**Hume Planning Scheme Amendments C207 and C208: Sunbury South and
Lancefield Road PSPs Permit Application Nos (P18858, P18854, P18855)**

Expert Witness Report

Drainage Evidence – 60 Buckland Way

14 August 2017

Figure 1 MWC Plan labelled “DSS 6815 Draft Plan, 30 November 2016

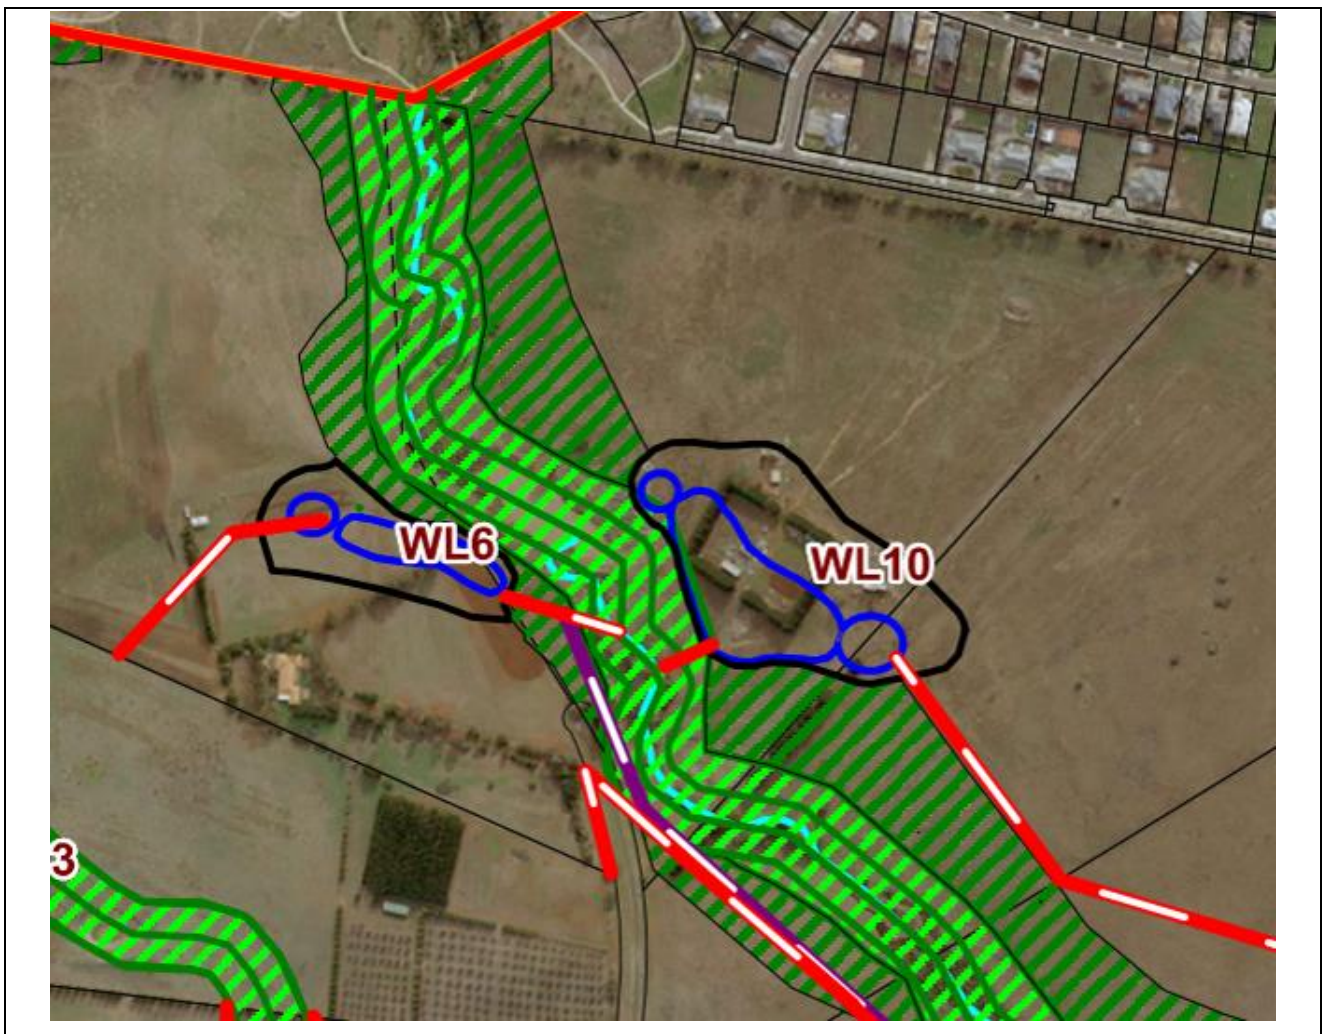
The 2016 plan shows three encumbered allocations of land in the subject site being:

- Land associated with the exiting Harpers Creek waterway and its riparian zone, including the area affected by the 1% Annual Exceedance Probability (AEP) flood event (light green hatch, Figure 1),
- Land identified as “landscape values” (dark green hatch, Figure 1), and
- Land associated with proposed wetland WL10.

Once all of the above are taken into account, the remainder of land identified as developable is in the order of 9.6 ha, representing about 49% of the subject site. This excludes any additional provision for local parks within the developable area.

Although not examined in detail, I agree that the land allocated for the Harpers Creek waterway and its riparian zone is reasonable to apply in this instance, particularly given the creek erosion issues.

Figure 2 Extract of a MWC plan labelled “Fox Hollow Drive DSS 6815 Preliminary Plan, 3 August 2017”

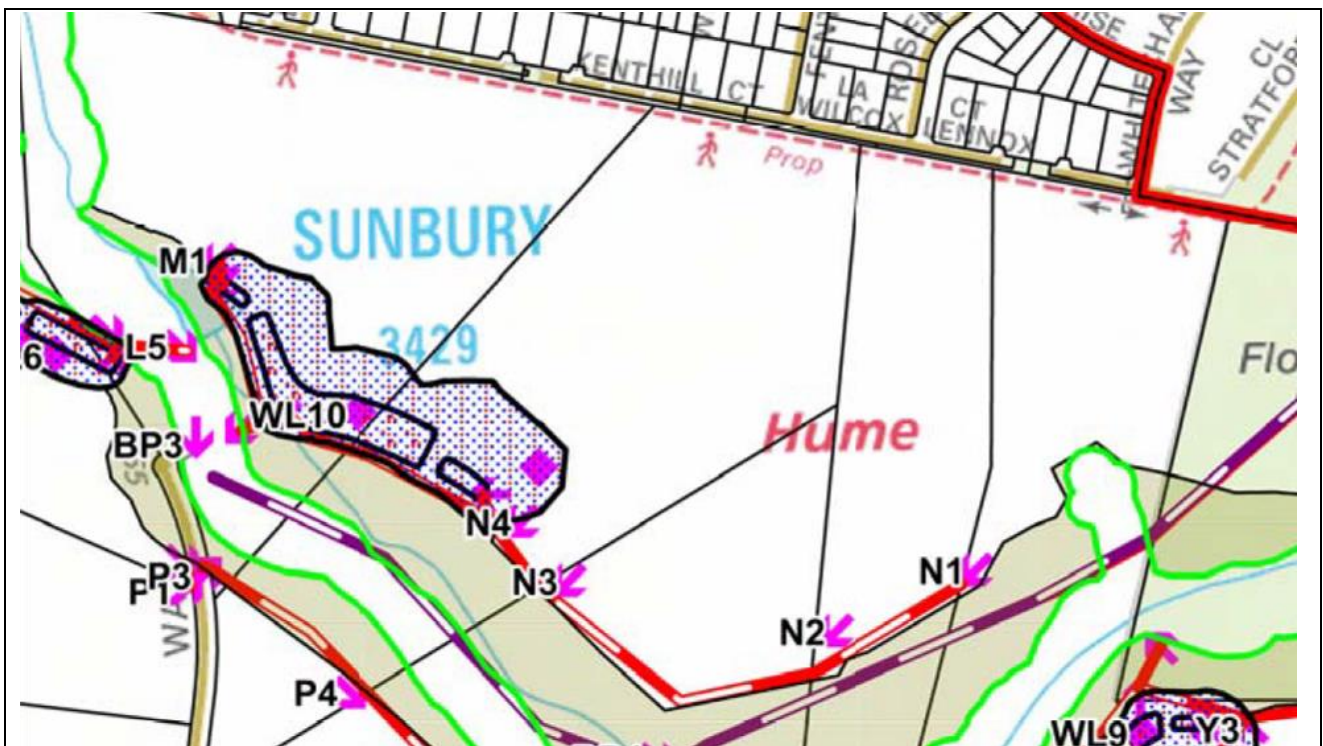
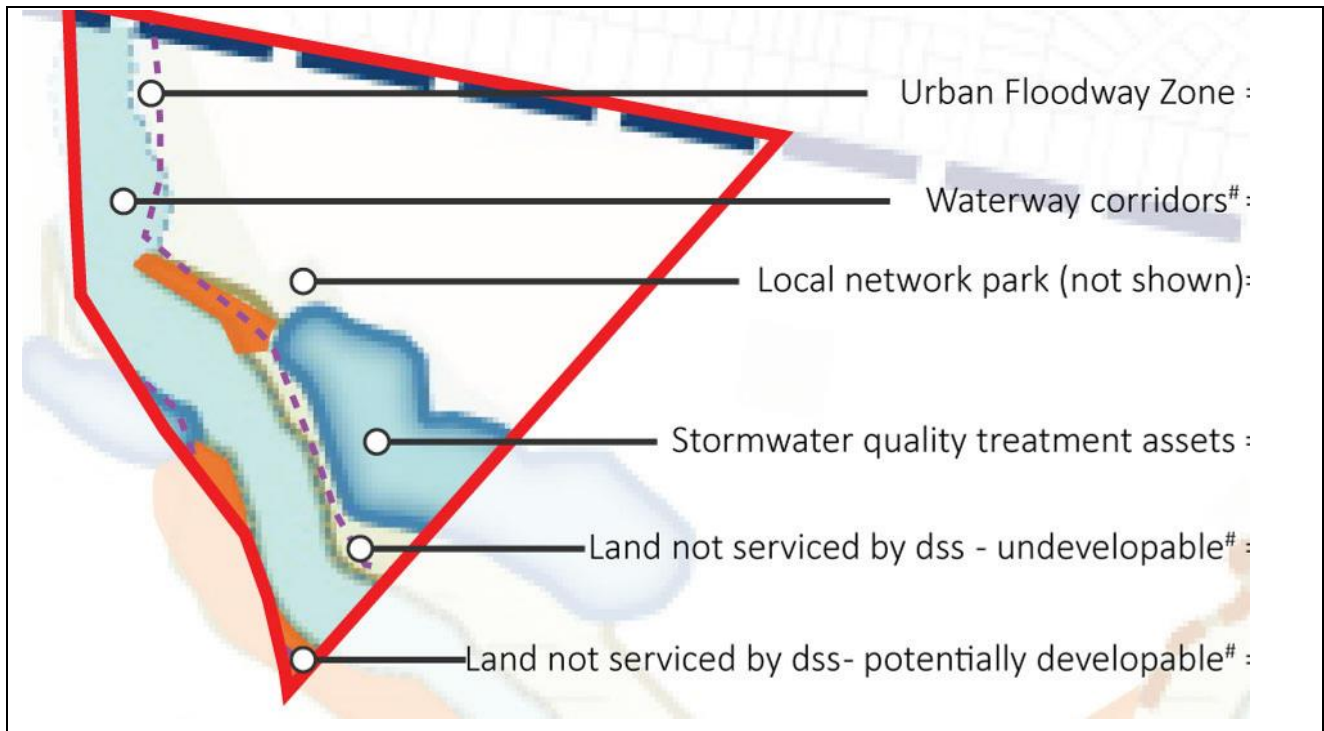
The current DSS proposals increase the developable land on the subject site to in the order of 11.6 ha, representing about 59% of the subject site. This excludes any additional provision for local parks within the developable area.

As detailed in Figures 2 and 3 above, the latest DSS plan released by MWC has substantially reduced the “Landscape Values” area within the subject site. I generally agree that the remainder of the area shown, being low, steep and relatively close to the receiving body of Harpers Creek, would be difficult to drain via pipelines to a regional wetland system. I agree complete removal of classification of land identified as “landscape values” from the subject site should not occur. The updated August 2017 plan is a reasonable representation of delineating developable which can be drained via gravity to a regional wetland system (either located on, or south east of the subject site). Notwithstanding the above, it is recognised that construction of dwellings within the urban floodway zone is prohibited.

I consider that the proposed planning controls for the potentially developable ‘landscape values’ land are appropriate from a drainage engineering perspective, although care in the design development of drainage pipelines servicing this area must occur to ensure the area can drain under gravity to WL10.

Figure 4 Assumed Sediment Pond and Wetland Characteristics Based on MWC August 2017 DSS plan

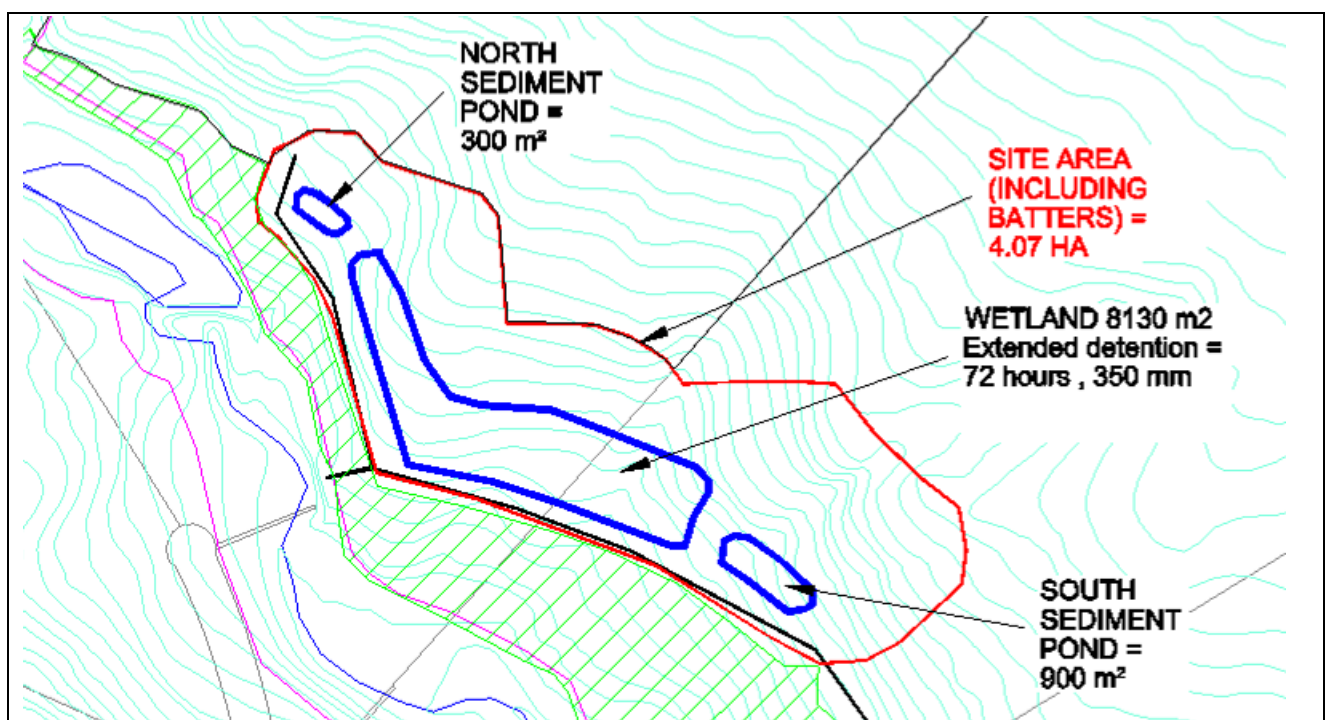
The “solution curve” for Harpers Creek in the vicinity of the subject site is reproduced as Annexure 1. This Figure appears to indicate that there is ample storage available (over 2,800 m³) in the 350 mm extended detention range of WL10 to meet the above objectives with minimal bypass flow.

As such, I consider that the design of the wetland can follow normal wetland design procedures without consideration of additional flood storage provisions in excess of the extended detention range (being 350 mm above Normal Water Level (NWL)). In fact the wetland is over sized to meet the criteria described in this section.

Figure 5 MUSIC Model – Assessment of August 2017 DSS Proposals

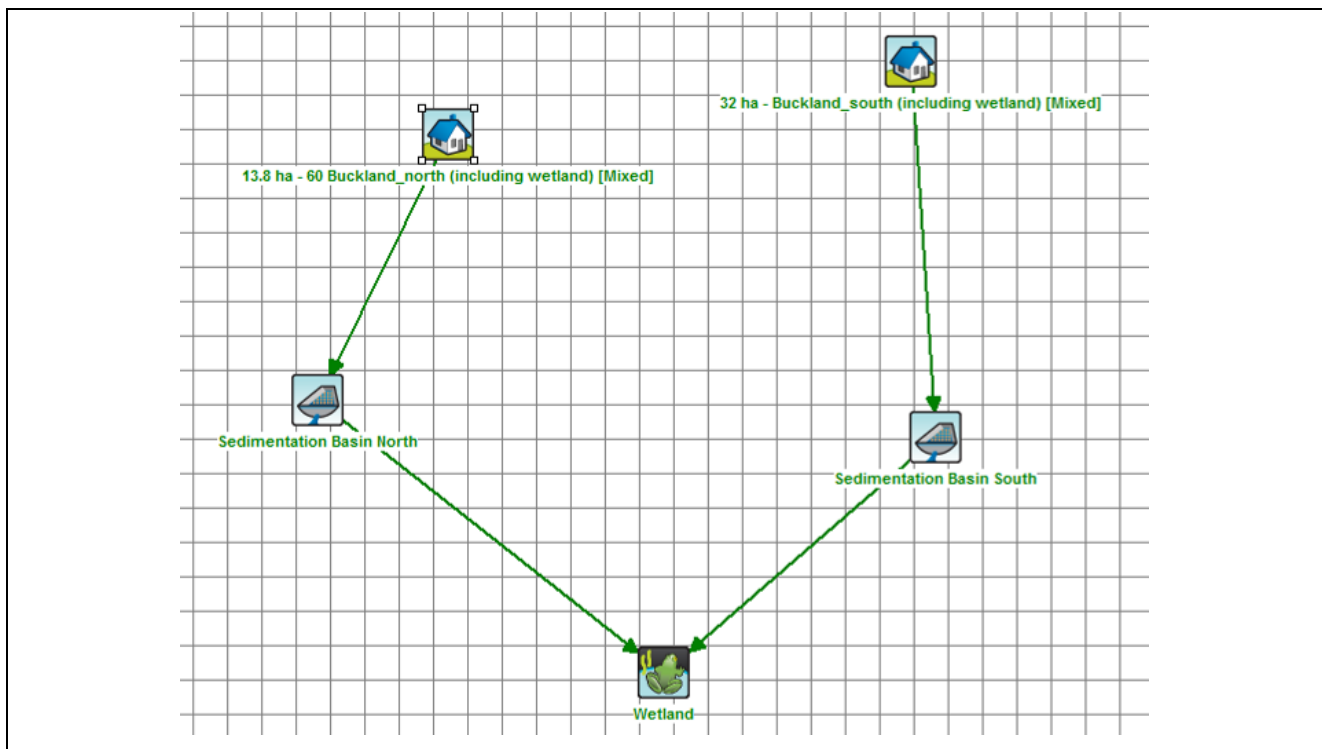
- 85.6 % removal of TSS,
- 73.8 % removal of TP, and
- 52.2 % removal of TN.

Given the above, I conclude that the current MWC DSS proposal for wetland WL10 is oversized to meet the stormwater pollutant retardation requirements of the DSS.

Figure 6 Alternative Design of WL10 - Relocated to “Land Not Served by DSS (developable and undevelopable) within 40 Buckland Way and 50 Fox Hollow Drive

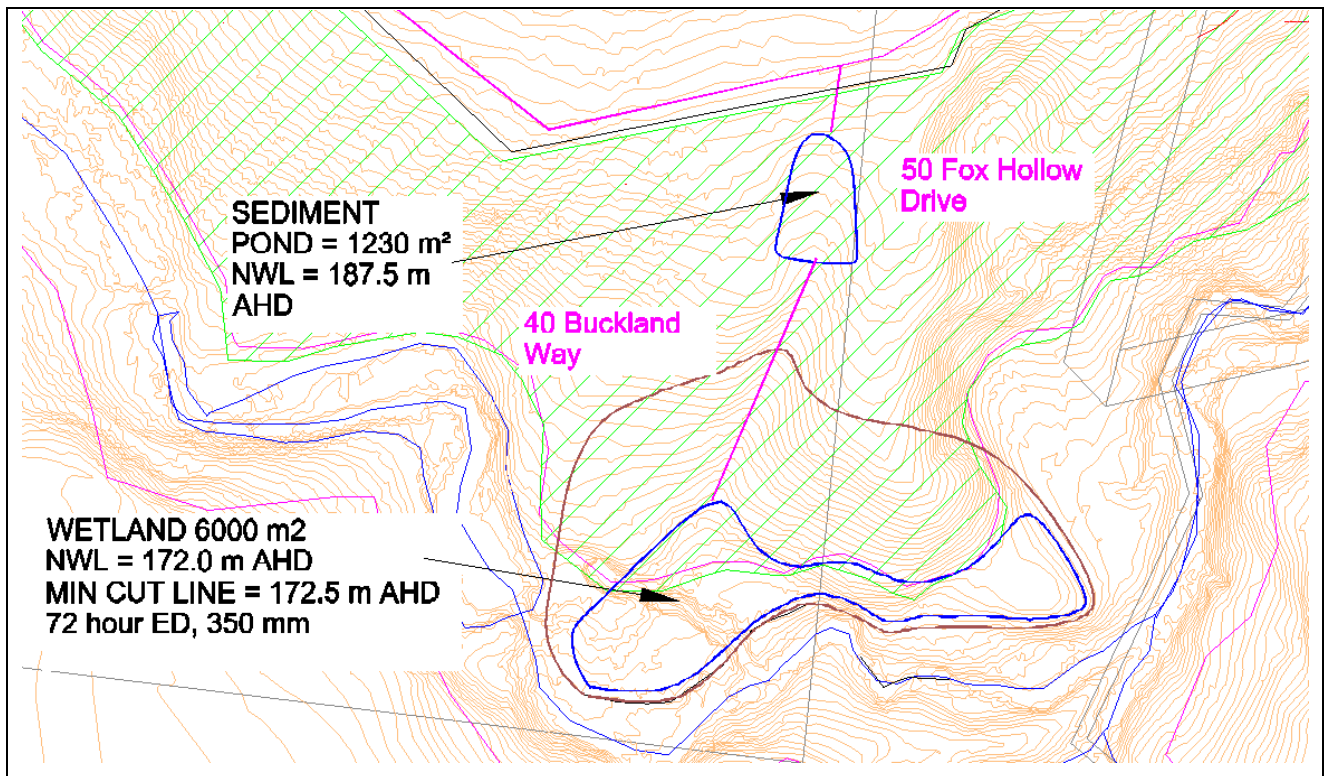
The proposal as detailed in Figure 6 increases the developable land on the subject site to in the order of 13.8 ha, representing about 71% of the subject site. This excludes any additional provision for local parks within the developable area. As such, the MUSIC analysis as detailed below is conservative in regard to stormwater pollutant removal efficiencies.

The proposal detailed in Figure 6 has the advantage of locating both the sediment pond and wetland within the area identified within the DSS as having “landscape values”. The sediment pond could be moved further south if required to enable development of 40 Buckland Way and 50 Fox Hollow Drive within the “Land Not Served by DSS but defined as possibly developable”. All land to the north of the proposed site can be drained under gravity to the sediment pond and wetland system as it is now located within the lowest area of the catchment.

As at least part of the wetland detailed as Alternative 1 is probably within the defined 1% AEP flood extent of Harpers Creek, the design development will be required to ensure the following (in addition to the usual MWC requirements):

- That an access path can be located around the wetland to MWC maintenance requirements above the 10 year ARI (10% AEP) flood level in Harpers Creek, and
- That the 100 year ARI (1% AEP) velocity from the creek over the wetland is less than 0.5 m/s

Figure 7 MUSIC Model – Wetland Alternative 1

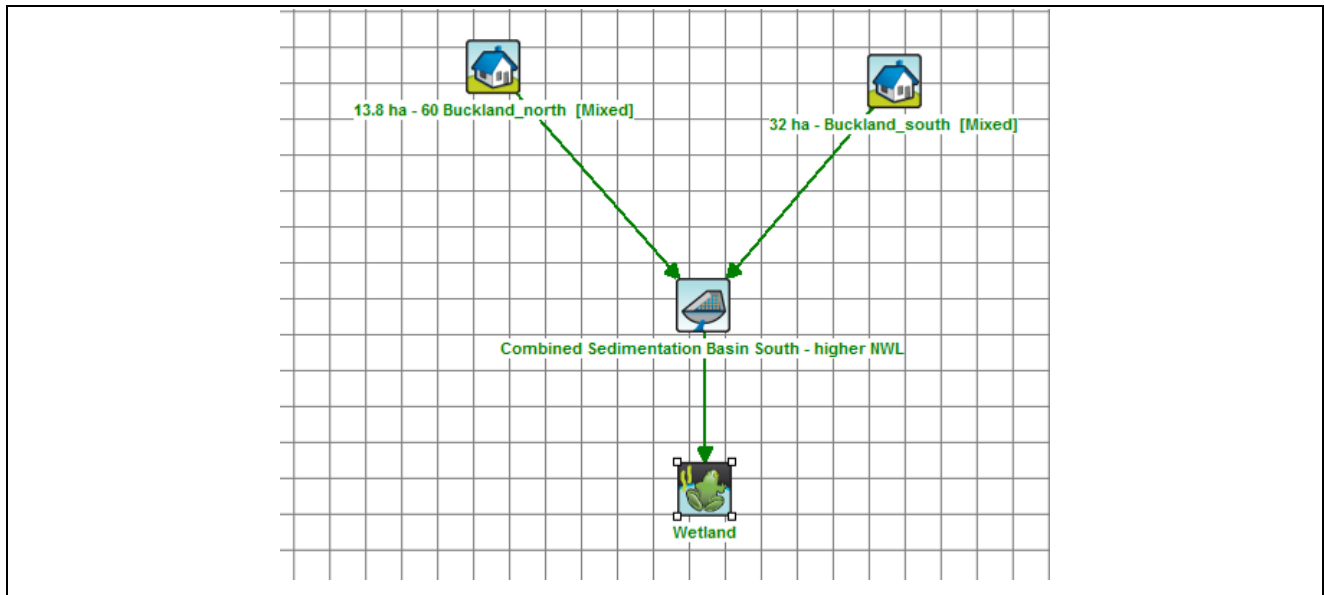
The results of the MUSIC modelling for Alternative 1 are detailed below. As shown, this the alternative design can meet best practice in regard to stormwater pollutant retention.

- 80.8 % removal of TSS,
- 67.7 % removal of TP, and
- 45.8 % removal of TN.

Figure 8 Alternative Design of WL10 - Reducing Encumbered Land on the Subject Site.
 (NWL = normal water level, EMB = Embankment Crest Level)

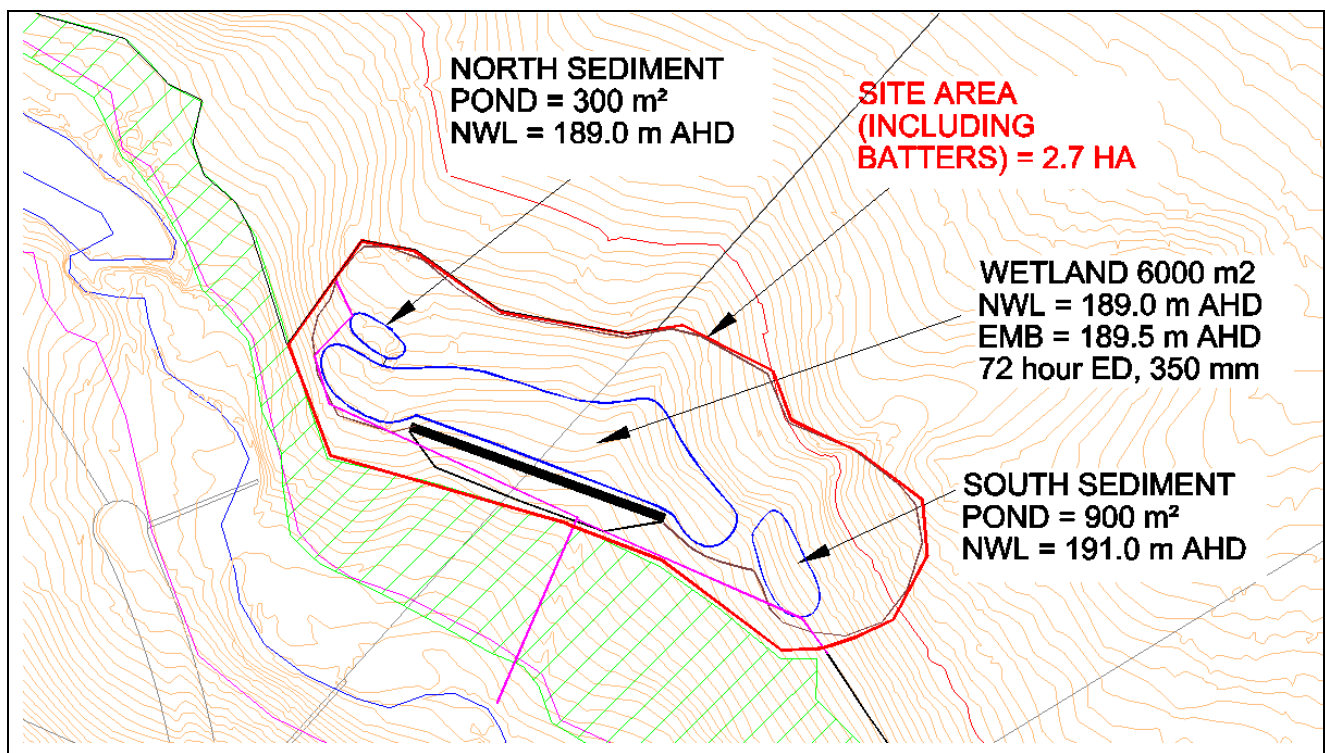
A large amount of the site allocation is due to batter requirements (1 in 5 assumed to current MWC standards). Battering into a steep slope can result in over 60 metres of site allocation away from the wetland just for the batter. Incorporating an embankment on the downslope of the system will help reduce battering requirements by allowing a higher Normal Water Level (NWL) in the system. The embankment I have detailed in Figure 8 would be 750 mm above the NWL. This type of design is as incorporated in the existing Holder Reserve wetland located on the eastern edge of the existing Jacksons Hill Estate (2005 concept and functional design by Ecological Engineering and Stormy Water Solutions).

To further reduce battering requirements I have incorporated a design where the south sediment pond has a normal water level 2 metres higher than the wetland and north sediment pond. Preliminary analysis indicates that pipe outfalls from the south east can still be achieved with this higher normal water level. The normal water level of the north sediment pond is the same as the wetland to ensure adequate pipe outfall provisions from the subject site.

Lastly I have reduced the normal water level area of the wetland to 6000 m². The sediment pond areas remain as per the current DSS proposals. The MUSIC model as detailed above predict the following stormwater pollutant reductions if this wetland reduction is accounted for:

Figure 9 MWC plan dated April 2017 and entitled “Harpers Creek DSS

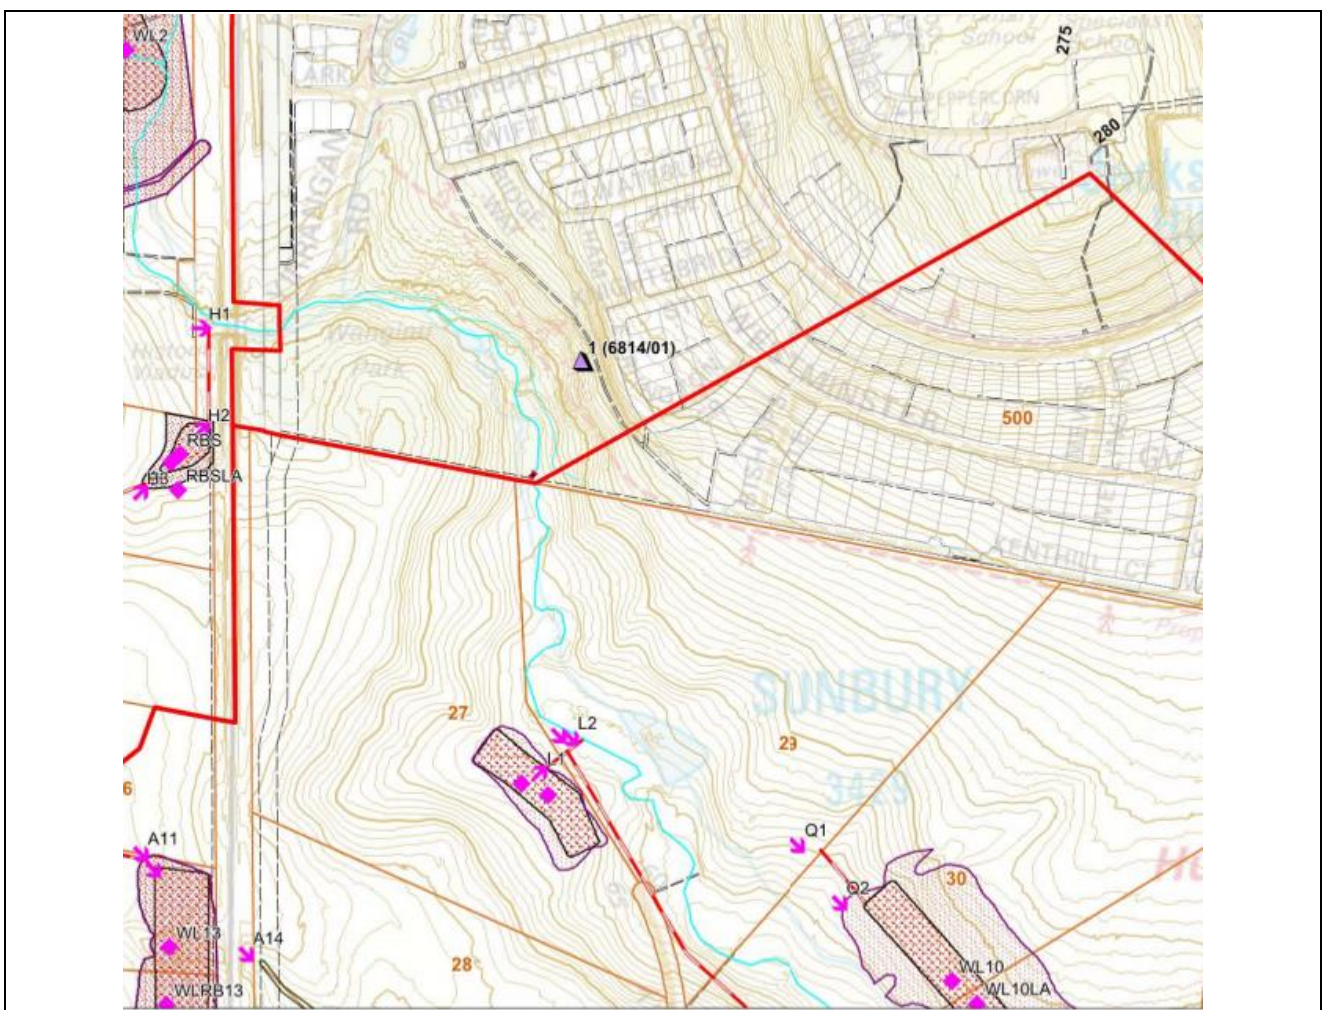
As detailed in Figure 9, as recently as April 2017 MWC were considering locating WL10 outside the subject site. It is understood that the MWC DSS wetland proposal was recently moved to within the subject site due to PSP proposed road interface constraints. I would suggest that the better place to have moved WL10 would be to the low point in the area as defined in Section 4.1 above, rather than higher in the catchment as defined by the location of WL10 within the subject site.
